**SITE PLAN: LOT 340, PHASE 4,  
THE PARKE AT OCEAN PINES, SECTION 16 OF OCEAN PINES  
THIRD TAX DISTRICT, WORCESTER COUNTY, MARYLAND**

**84  
CHATHAM**

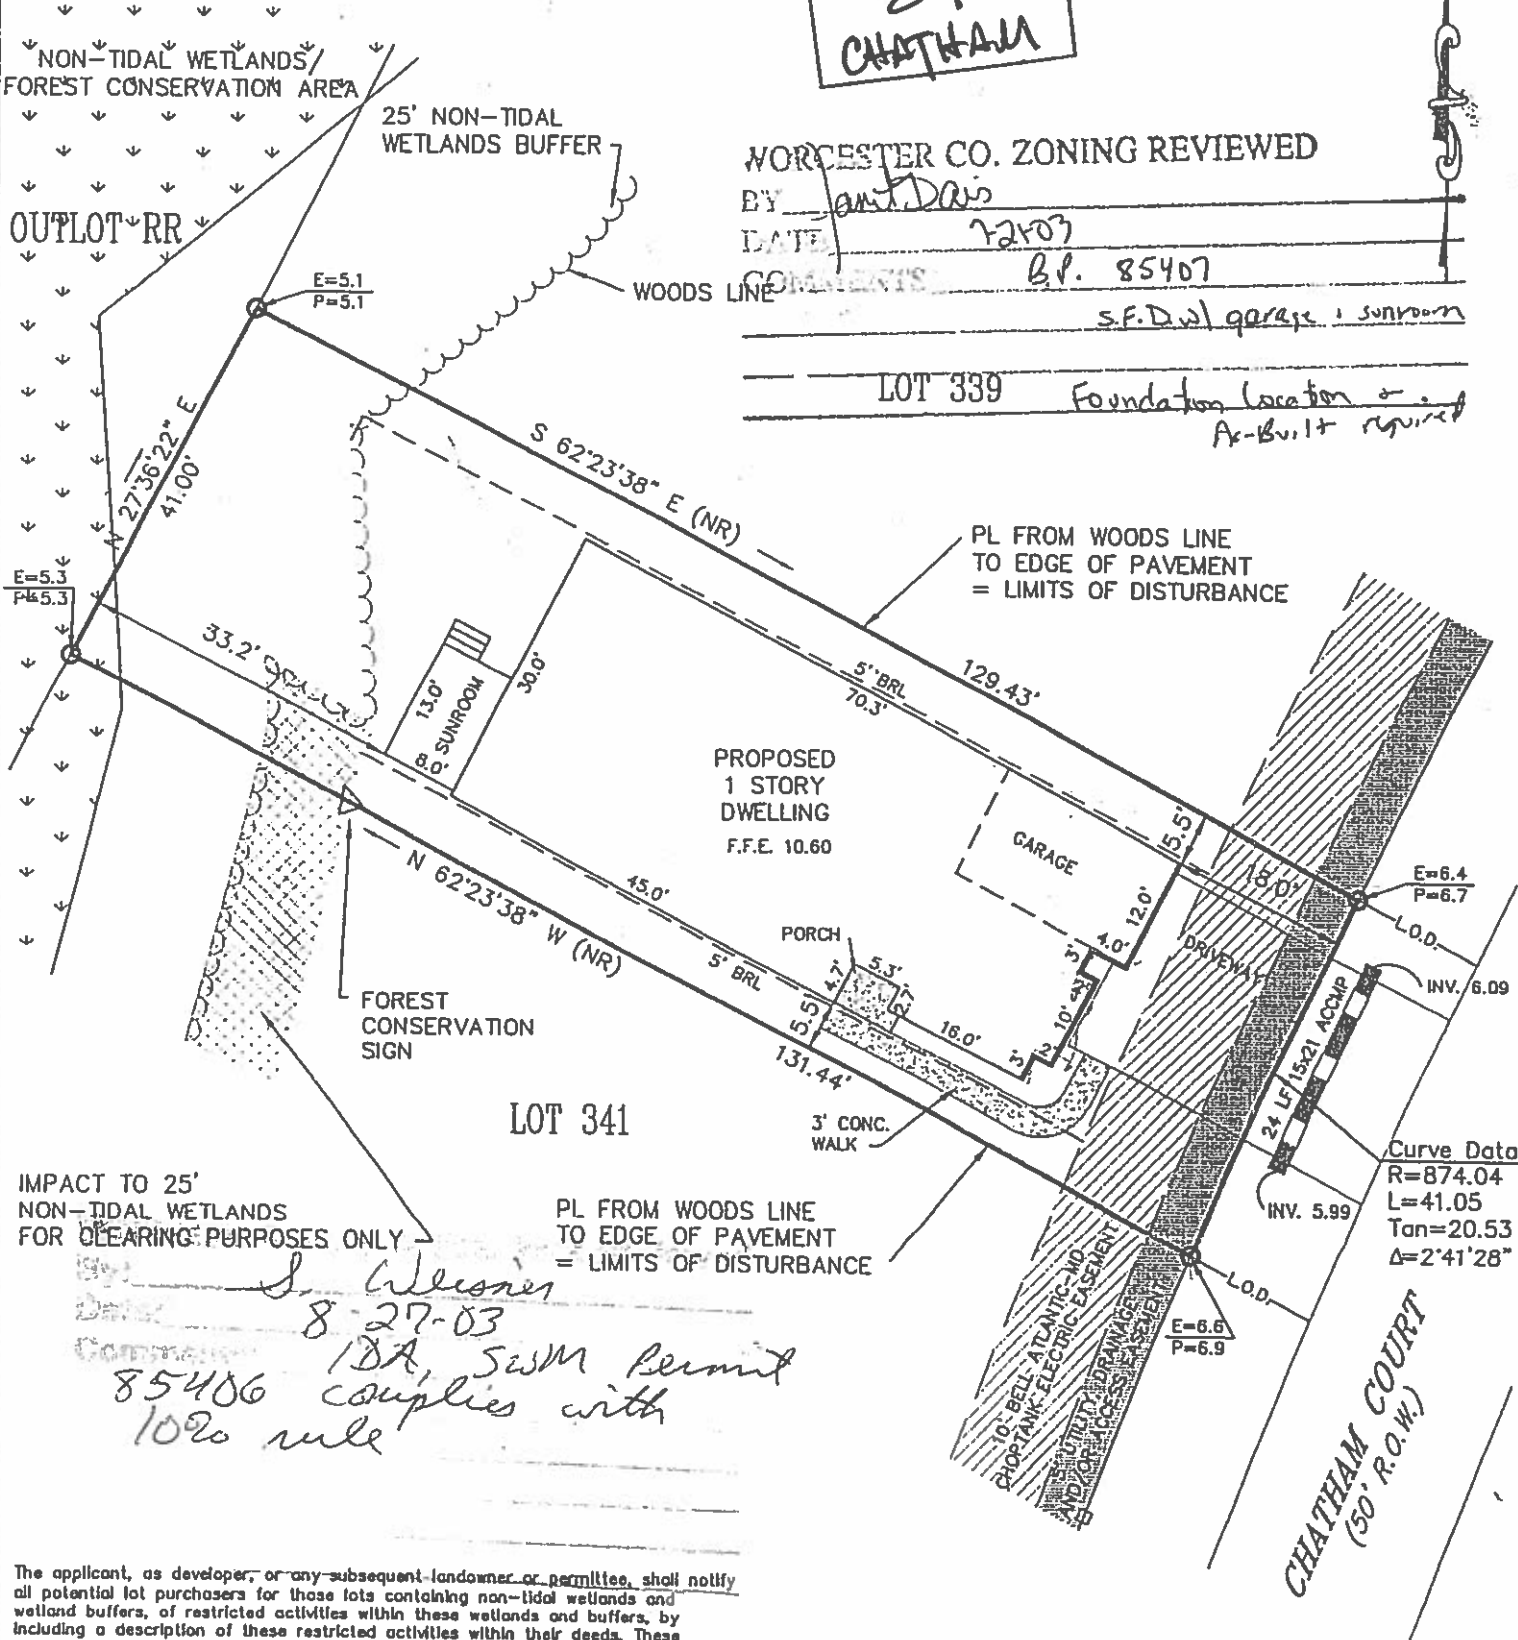
WORCESTER CO. ZONING REVIEWED

COMMENTS B.P. 85407

S.F. D.w/ garage + sunroom

LOT 339 Foundation location +

As-Built required

*S. Wilson*  
Date: 8-27-03  
Comments: IDA, SWM Permit 85406 complies with 1020 rule
